City of Sedona Wastewater Department

The City of Sedona, Arizona is issuing **Addendum # 2** to the plans and specifications as originally issued at the time of solicitation for bids for the **WWRP Tertiary Filter Improvements Project**. For any bid to be considered responsible and responsive, receipt of this addendum must be acknowledged.

CITY OF SEDONA, AZ
TERTIARY FILTER IMPROVEMENTS
 MECHANICAL
FILTER PLAN

CITY OF SEDONA, AZ
TERTIARY FILTER IMPROVEMENTS
MECHANICAL
FILTER
SECTIONS AND DETAILS

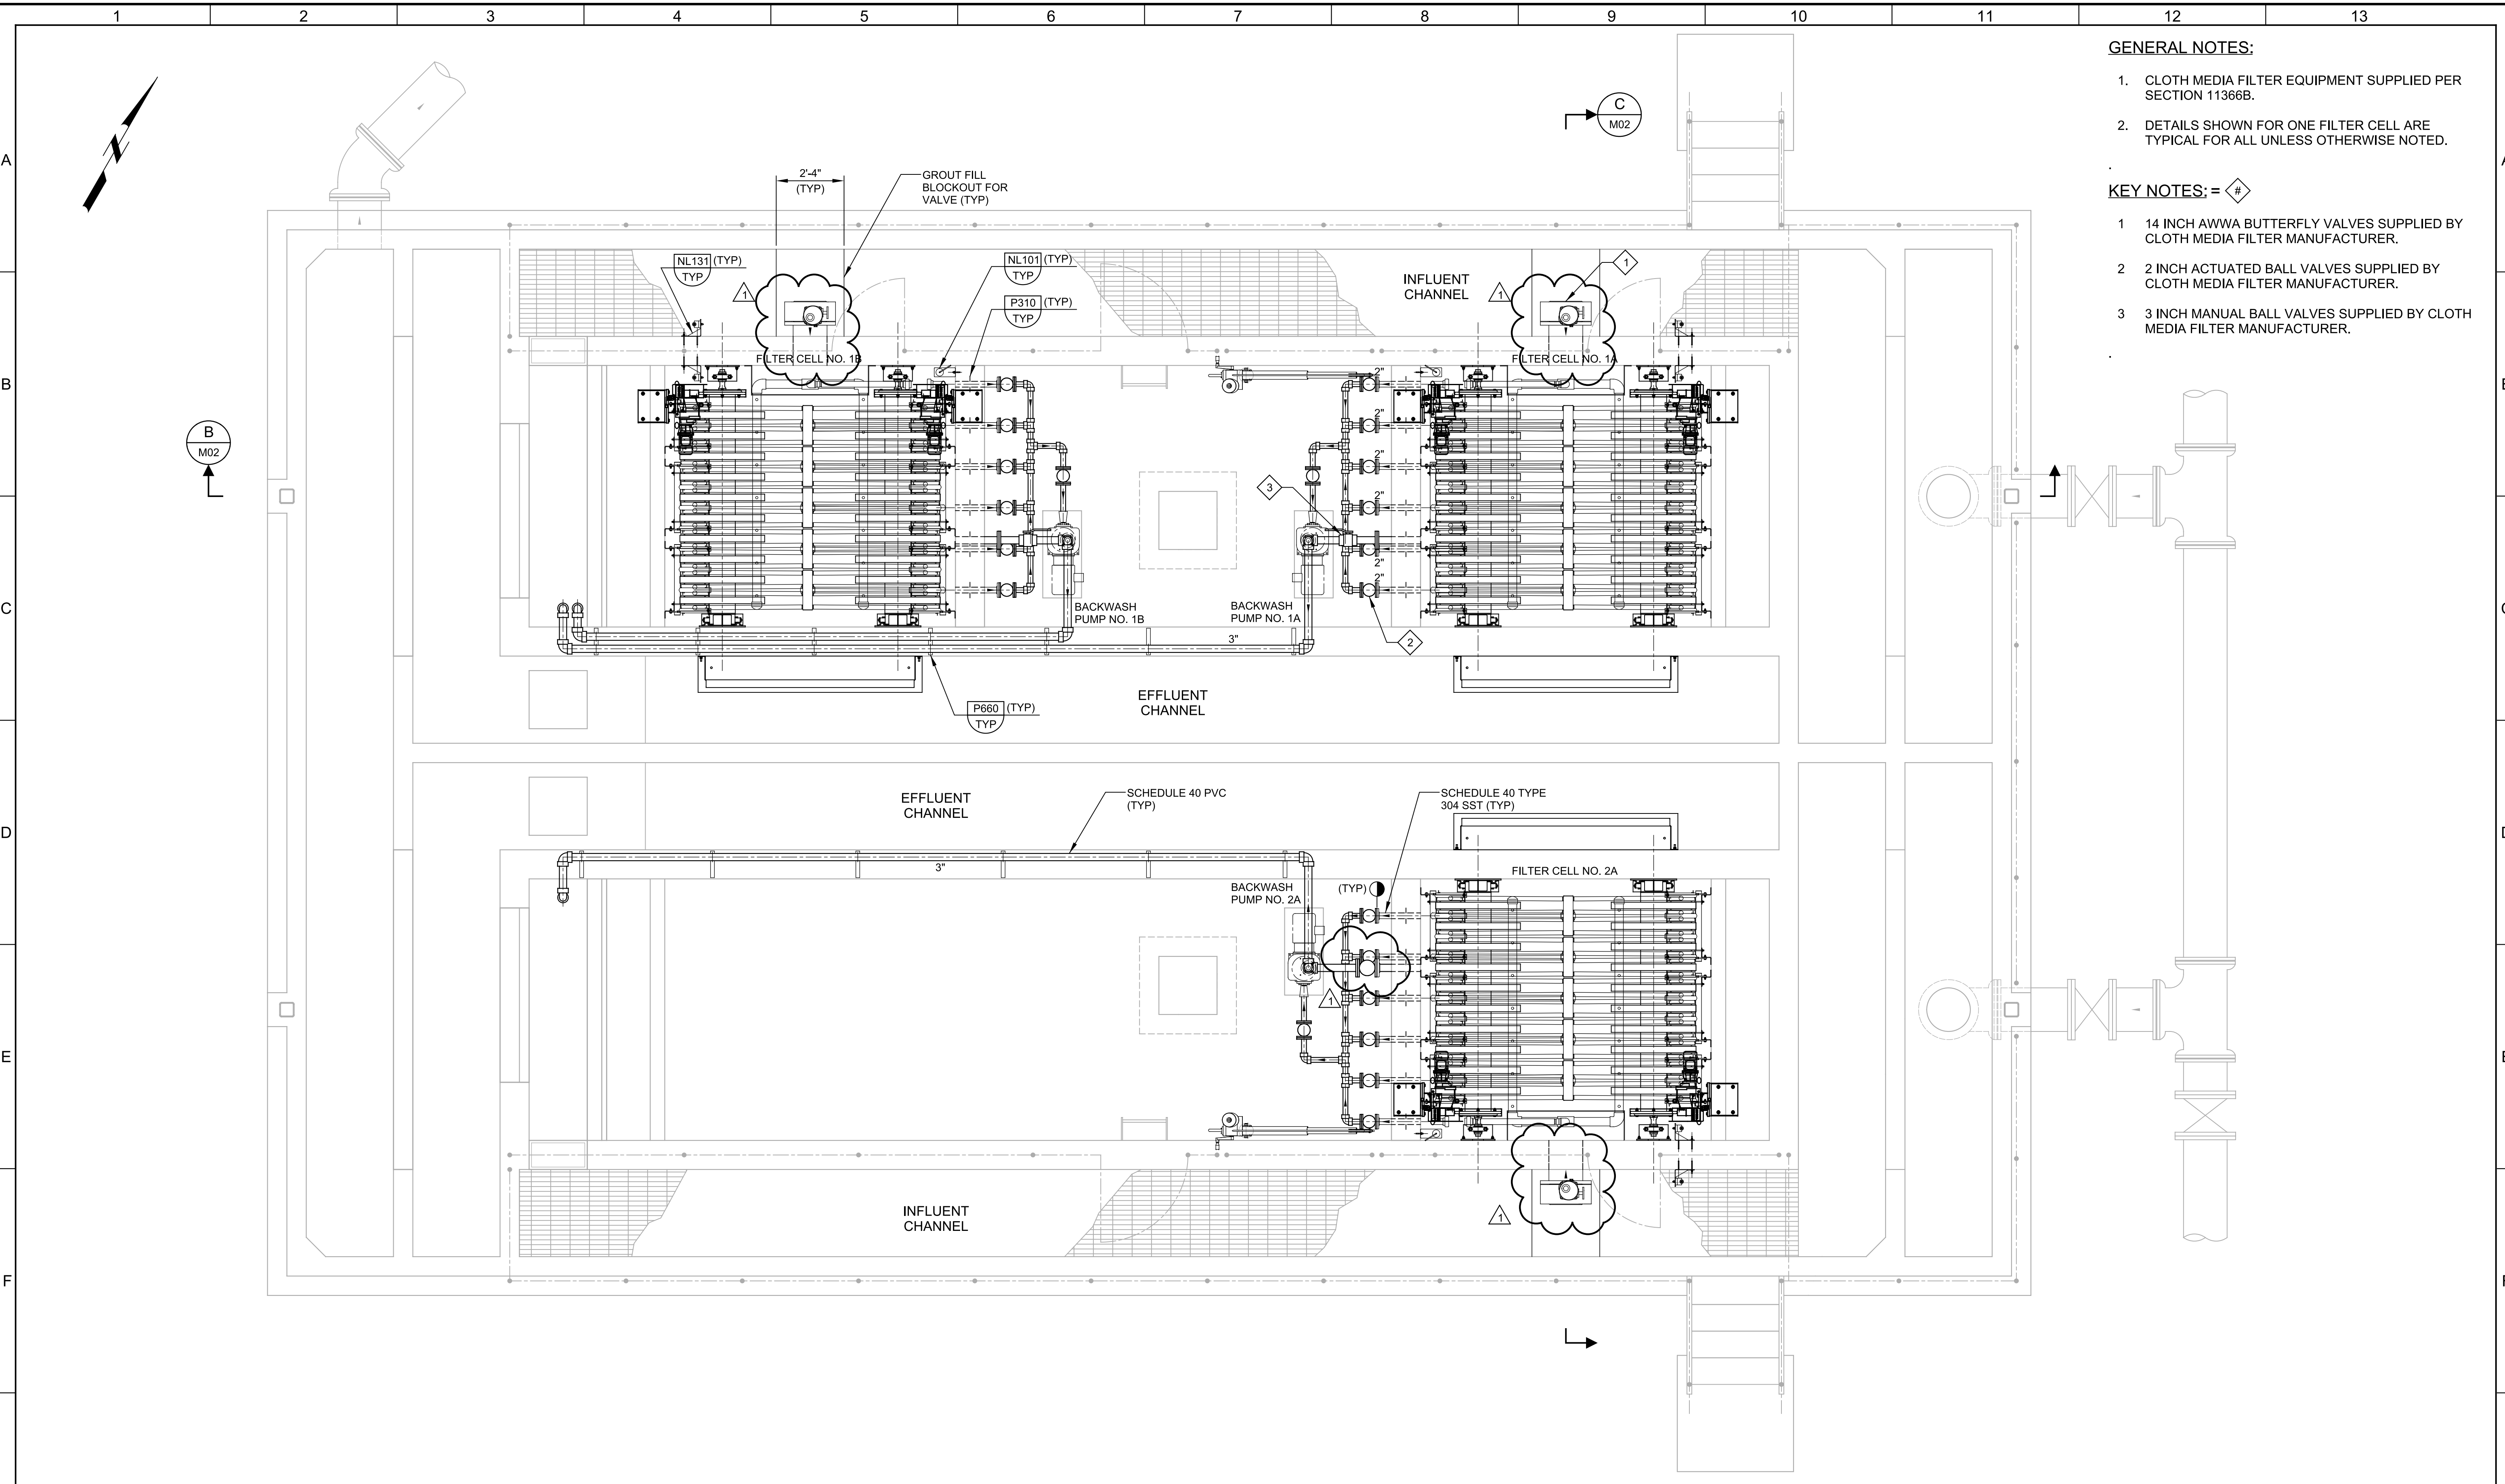
8. **Drawings: REPLACE** drawings M-01 and M-02 with the attached.

Description of changes: Changed the valves on the discharge of the backwash pumps to be shown as flanged instead of threaded, to match the specification. Added "TYP" in several locations to clarify typical requirements. Other minor clarifications.

- GENERAL NOTES:**
1. CLOTH MEDIA FILTER EQUIPMENT SUPPLIED PER SECTION 11366B.
 2. DETAILS SHOWN FOR ONE FILTER CELL ARE TYPICAL FOR ALL UNLESS OTHERWISE NOTED.
- KEY NOTES: = #**
- 1 14 INCH AWWA BUTTERFLY VALVES SUPPLIED BY CLOTH MEDIA FILTER MANUFACTURER.
 - 2 2 INCH ACTUATED BALL VALVES SUPPLIED BY CLOTH MEDIA FILTER MANUFACTURER.
 - 3 3 INCH MANUAL BALL VALVES SUPPLIED BY CLOTH MEDIA FILTER MANUFACTURER.

REV	DATE	BY	DESCRIPTION
1	03-20-19	BDJ	PER ADDENDUM NO. 2
